IN THE MATTER OF THE APPLICATION
OF NEW MEXICO COPPER CORPORATION FOR
A GROUNDWATER DISCHARGE PERMIT FOR
THE COPPER FLAT MINE, DP-1840

No. GWB 18-06 (P)

**ENVIRONMENT DEPARTMENT'S STATEMENT OF INTENT
TO PRESENT TECHNICAL TESTIMONY**

GROUND WATER QUALITY BUREAU (GWQB)
DISCHARGE PERMIT
NEW COPPER MINE FACILITY
Issued under 20.6.2 and 20.6.7 NMAC

Figure 2 – Ground and Surface Water Sampling Locations

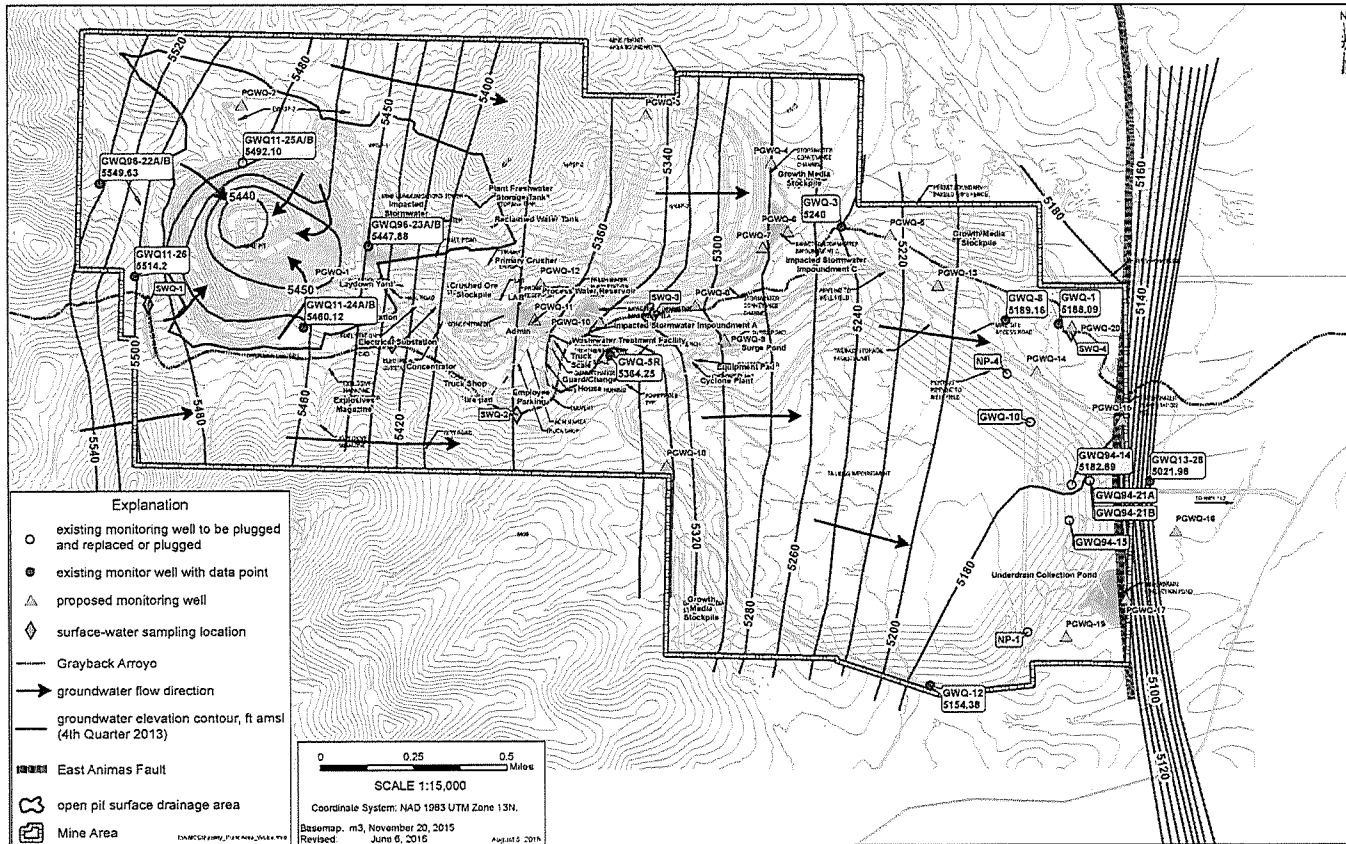
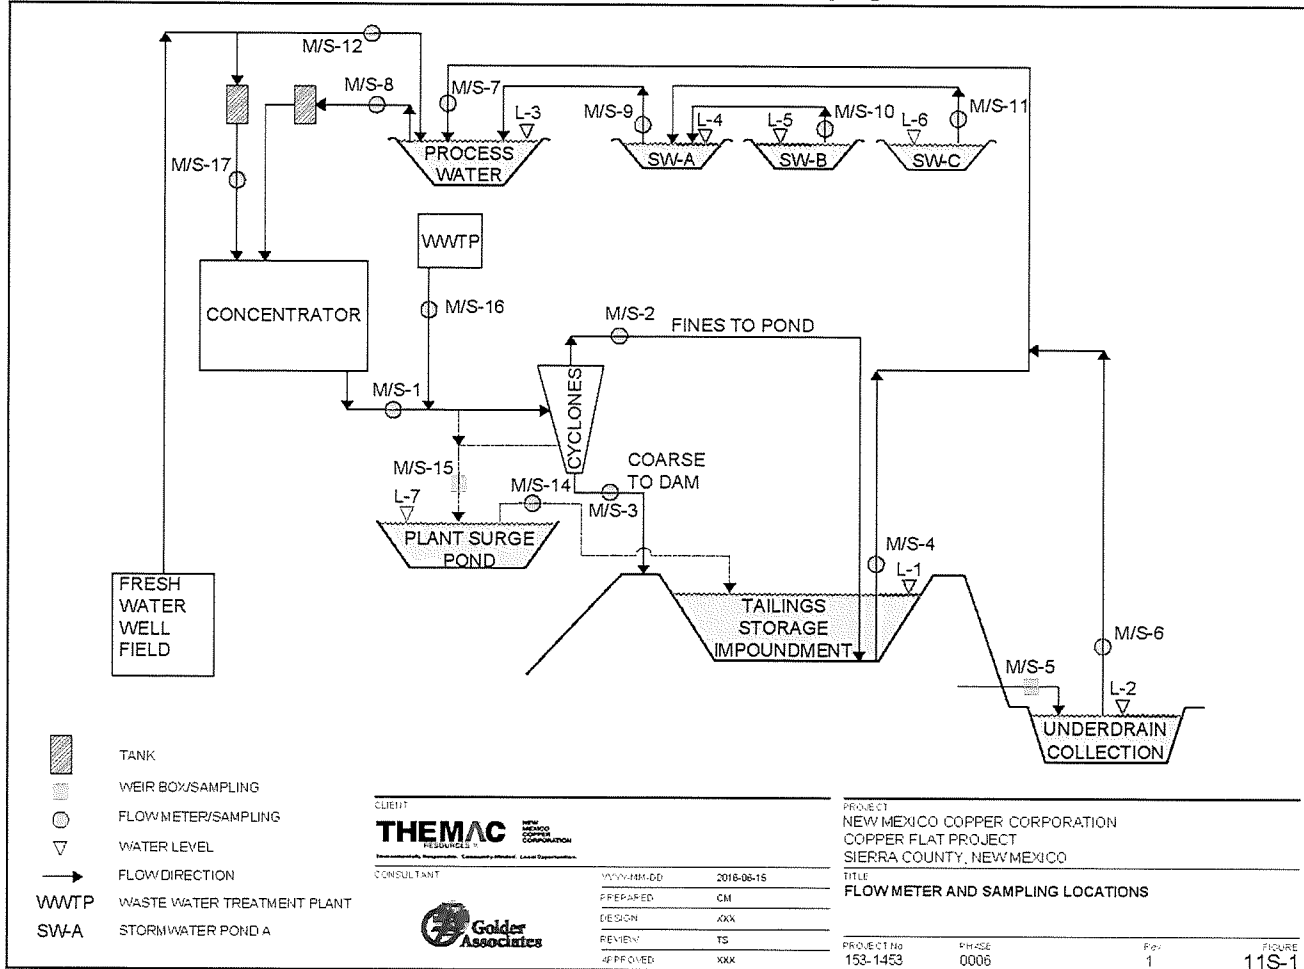
Commented [BR35]: Figure 2 has been updated to provide more clarity on the ground and surface water sampling locations.
